# Access Compliance Report

## Public Rights-of-Way

Intersection ID: 47972	Main Street: ALHAMBRA_LN	Cross Street: SOUTH_CREEK_RD	Location: SE
ADA ID: 4D8299FB1B57	Ramp Type: PerpDiag	Initial Pass/Fail: Fail	Overall Compliance: No
			Severity Score: 21.25

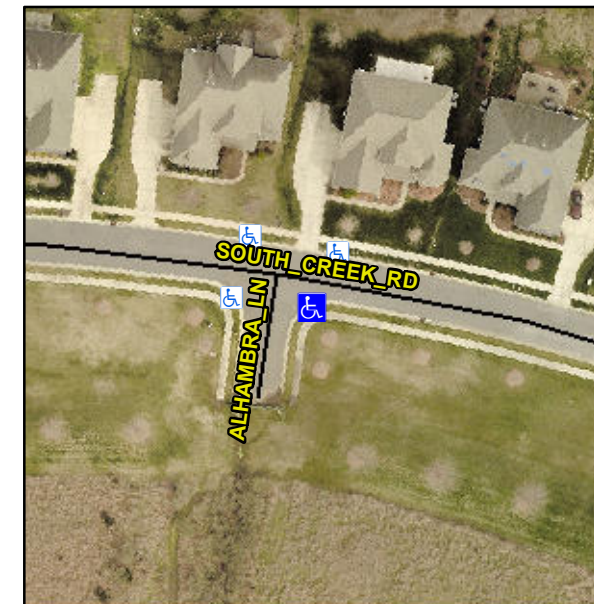
**Not Found, R304.5.1, R304.5.3**

Compliance	Description	Data	Compliance	Description	Data
N/A	Ramp Length (in)	47.0	Yes	Ramp Slope (%)	5.0
No	Ramp Width (in)	46.0	No	Ramp XSlope (%)	5.3
N/A	Flare Type LT	N/A	N/A	Flare Type RT	N/A
N/A	Flare Slope LT (%)	N/A	N/A	Flare Slope RT (%)	N/A
N/A	Flare Traversable LT?	N/A	N/A	Flare Traversable RT?	N/A
N/A	Landing Length (in)	N/A	N/A	DWS Provided?	N/A
N/A	Landing Width (in)	N/A	N/A	DWS Contrast?	N/A
N/A	Landing Slope (%)	N/A	N/A	DWS Length (in)	N/A
N/A	Landing X Slope (%)	N/A	N/A	DWS Full Width?	N/A
N/A	Landing Curb? (Y/N)	N/A	N/A	DWS Offset (in)	N/A
N/A	Shared Landing?	N/A			
N/A	Gutter Ponding?	N/A	N/A	Gutter Slope (%)	N/A
N/A	Gutter Lip Ht (in)	N/A	N/A	Gutter X Slope (%)	N/A
N/A	Painted X Walk1?	No	N/A	Painted X Walk2?	No
	X Walk 1 Direction	To NE		X Walk 2 Direction	To NW
N/A	X Walk 1 Width (in)	N/A	N/A	X Walk 2 Width (in)	N/A
	X Walk 1 Slope (%)	4.8		X Walk 2 Slope (%)	0.7
	X Walk 1 X Slope (%)	0.5		X Walk 2 X Slope (%)	5.9

**Remove & Replace Curb Ramp With Two New Directional Ramps or Equivalent.**
